**PRODUCT CHANGE NOTIFICATION COVERSHEET**

**CTS Part Number:** Model 632, 636, CB1V8, CB2V5

**Product Description:** HCMOS Clock Oscillator

**Reason for PCN:** Change notification for revised product marking format.

**Model 632 [drawing 008-0328-0]**

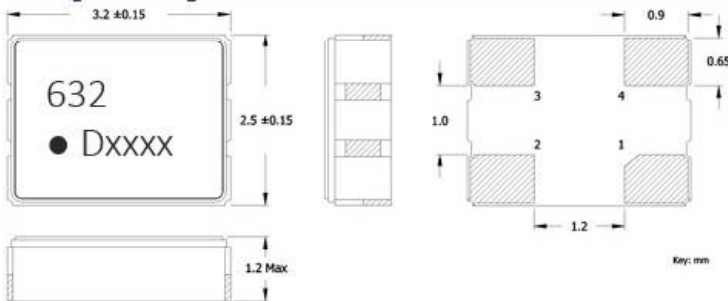
Change To - New Format, Revision F]

1. 632 – CTS Model.
2. D – Date Code. See Table I for codes.
3. xxxx – Frequency Code.  
3-digits, frequencies below 100MHz  
4-digits, frequencies 100MHz or greater  
[See document 016-1454-0, Frequency Code Tables.]

Change From - Old Format, Revision E]

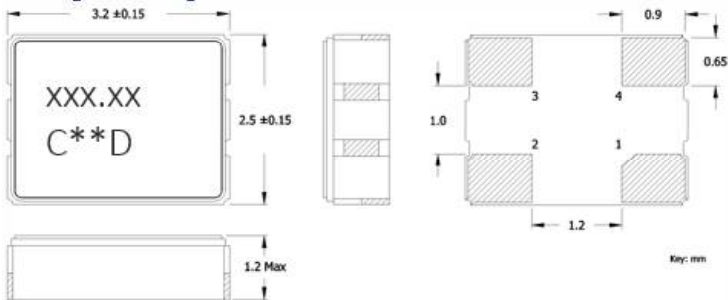
1. xxx.xx – Frequency in MHz.  
Frequency is marked with 1 - 3 leading significant digits before and 2 significant digits [including zeroes] after the decimal.

Marking Examples:

3.57954MHz = 3.57  
14.31818 MHz = 14.31  
125MHz = 125.00

2. C – CTS and Pin 1 identifier.
3. \*\* – Manufacturing Site Code.
4. D – Date Code. See Table I for codes.

**Model 636 [drawing 008-0250-0]**

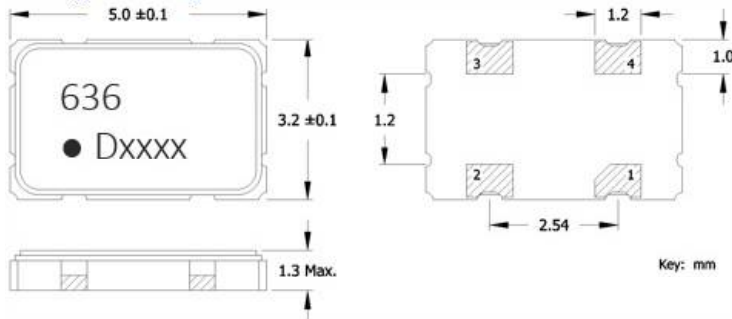
Change To - New Format, Revision J]

1. 636 – CTS Model.
  2. D – Date Code. See Table I for codes.
  3. xxxx – Frequency Code.  
3-digits, frequencies below 100MHz  
4-digits, frequencies 100MHz or greater
- [See document 016-1454-0, Frequency Code Tables.]

Change From - Old Format, Revision I]

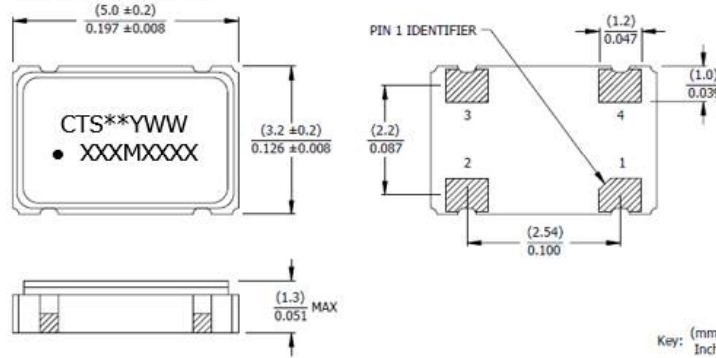
1. \*\* - Manufacturing Site Code.
2. YWW – Date code, Y – year, WW – week.
3. XXXMXXXX – Frequency is marked with only leading significant digits before the 'M' and 4 digits after the 'M' [including zeros].  
Ex. XXMXXXX [62M5000]  
XXMXXXX [155M5200]

**Model CB1V8 [drawing 008-0277-0]**

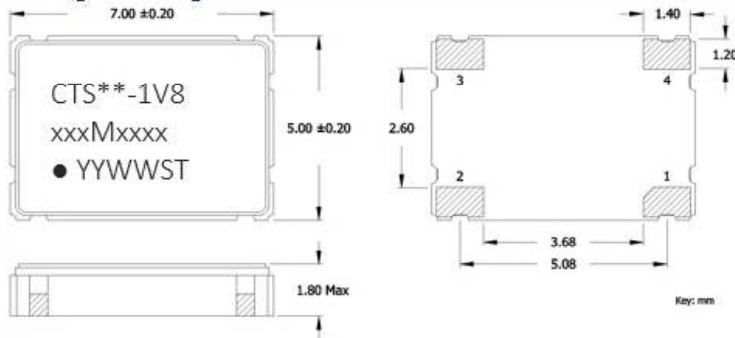
Change To - New Format, Revision C]

1. \*\* – Manufacturing Site Code.
2. xxxMxxxx – Frequency is marked with 1,2 or 3 leading significant digits before the “M” and 4 digits after the “M” [including zeroes].  
Ex. xMxxxx [3M5795]  
xxMxxxx [14M3181]  
xxMxxxx [25M0000]  
xxxMxxxx[125M0000]
3. YYWW – Date Code; YY = year, WW = week.
4. ST – Frequency Stability/Temperature Code.  
[Refer to ordering information for codes.]

Change From - Old Format, Revision B]

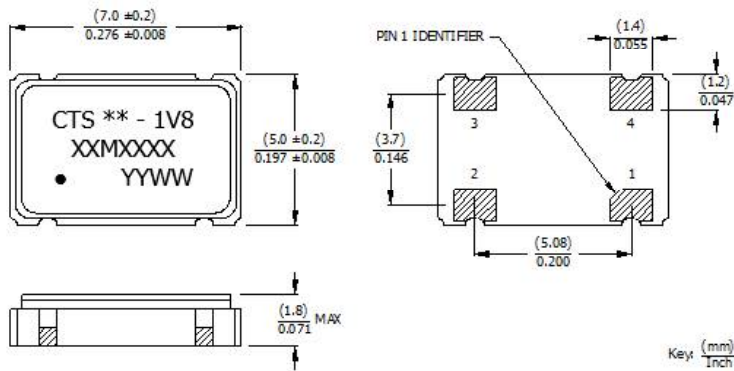
1. \*\* - Manufacturing Site Code.
2. XXMXXXX - Frequency marked with 4 significant digits after the 'M'.
3. YYWW – Date code, YY – year, WW – week.

**Model CB2V5 [drawing 008-0281-0]**

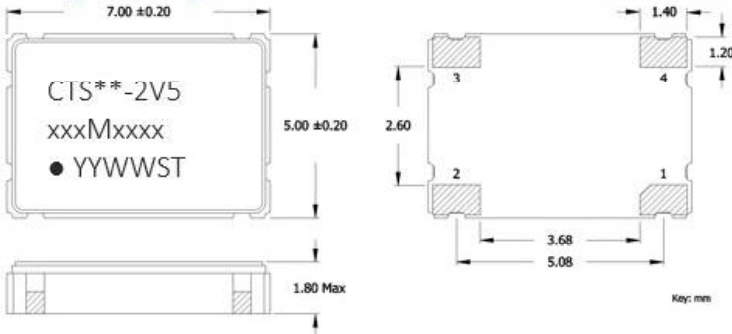
Change To - New Format, Revision C

1. \*\* – Manufacturing Site Code.
2. xxxMxxxx – Frequency is marked with 1,2 or 3 leading significant digits before the “M” and 4 digits after the “M” [including zeroes].  
Ex. xMxxxx [3M5795]  
xxMxxxx [14M3181]  
xxMxxxx [25M0000]  
xxxMxxxx[125M0000]
3. YYWW – Date Code; YY = year, WW = week.
4. ST – Frequency Stability/Temperature Code.  
[Refer to ordering information for codes.]

Change From - Old Format, Revision B

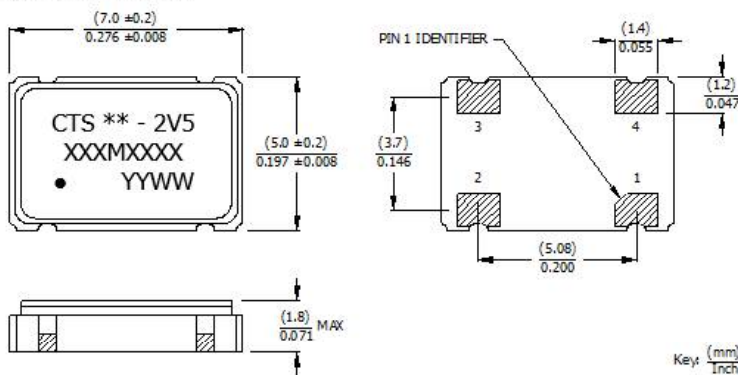
1. \*\* - Manufacturing Site Code.
2. XXXMXXXX - Frequency marked with 4 significant digits after the 'M'.
3. YYWW – Date code, YY – year, WW – week.
